Replacement Murray River bridge crossing at Swan Hill

Environmental Investigation Submissions Report

June 2013

Figure 1-1: Proposed Murray River crossing at Swan Hill

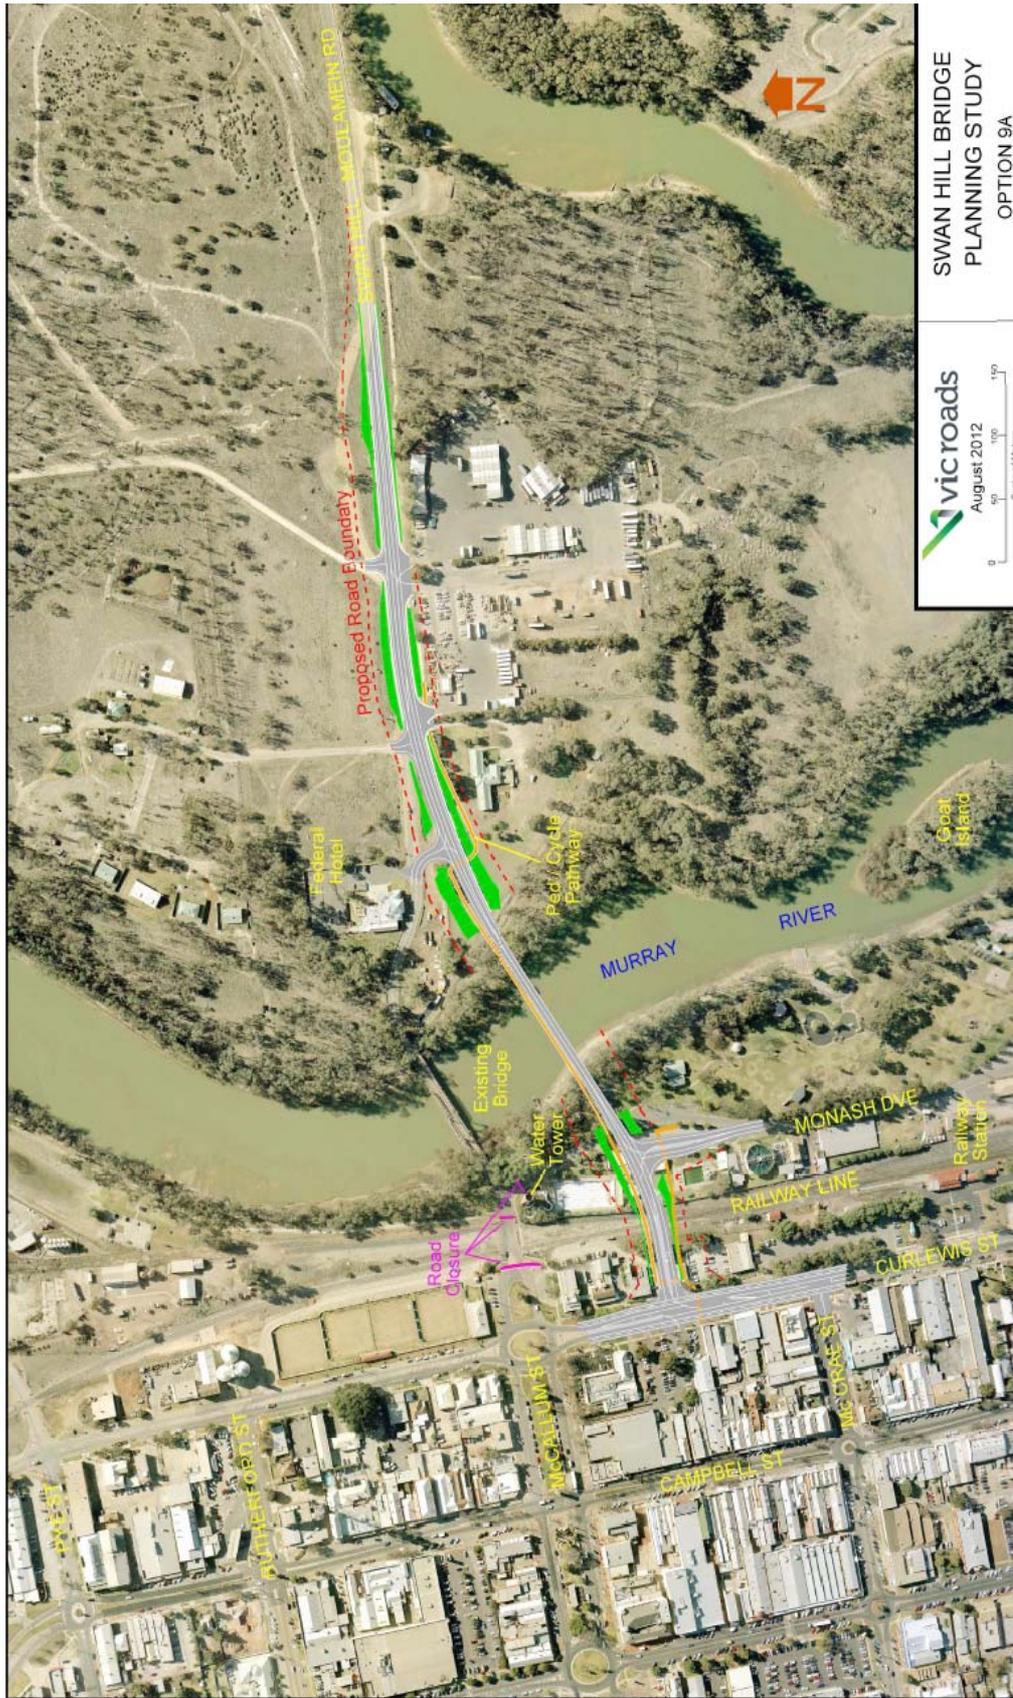
Response

The proposed road boundary (Figure 1) provides an indicative location of future road boundaries based on the concept design. Roads and Maritime would recommend to Wakool Shire Council that the Local Environment Plan include the proposed road boundaries and that land use zoning in the area is compatible with its future use as road reserve (refer to Section 5). Further, Roads and Maritime would ask Wakool Shire Council to advise any prospective developers of Roads and Maritime' future plans to realign the Swan Hill-Moulamein Road.
